THE GLEN AT WIDEFIELD FILING NO. 9
RESIDENTIAL SUBDIVISION CONSTRUCTION DRAWINGS
PREPARED FOR WIDEFIELD INVESTMENT GROUP

**GLEN AT WIDEFIELD FILING NO. 9
SPRING GLEN DRIVE (Sta. 43+00 to Sta. 45+89)
PLAN AND PROFILE
EL PASO COUNTY, COLORADO**

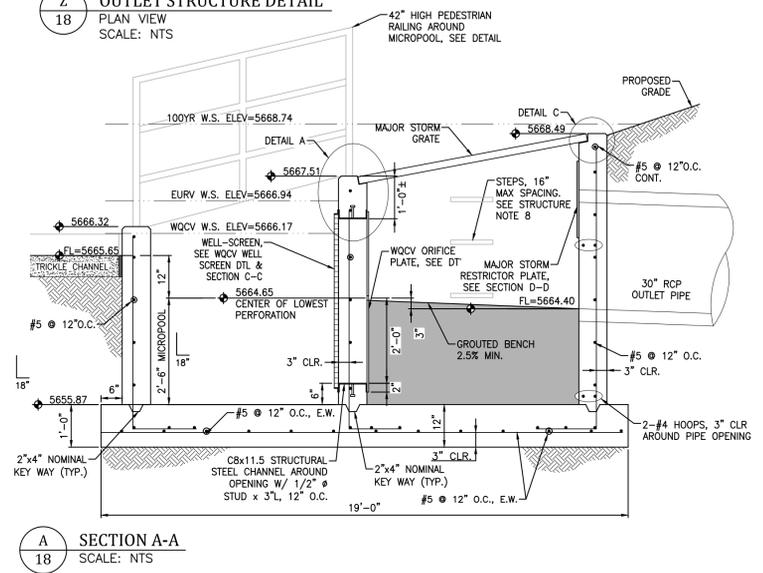
Pipe Dia and height above pipe invert does not match the drainage report design. Update one or the other to match. Unresolved. Drainage report designed for a 24" dia with

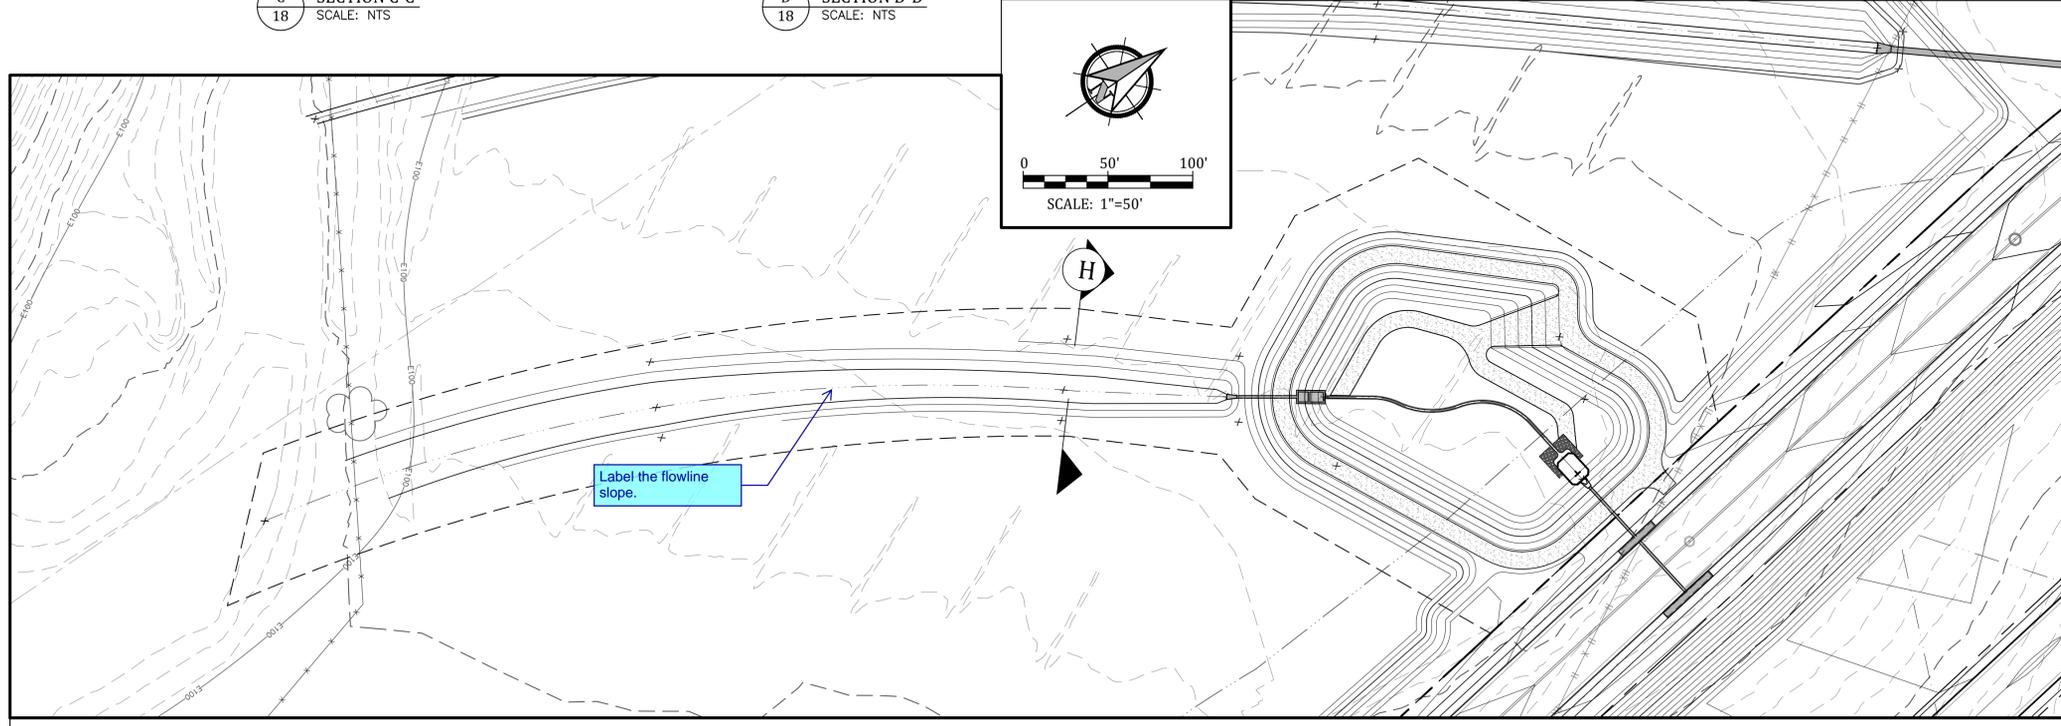
Identify the product or else note the required specifications needed.
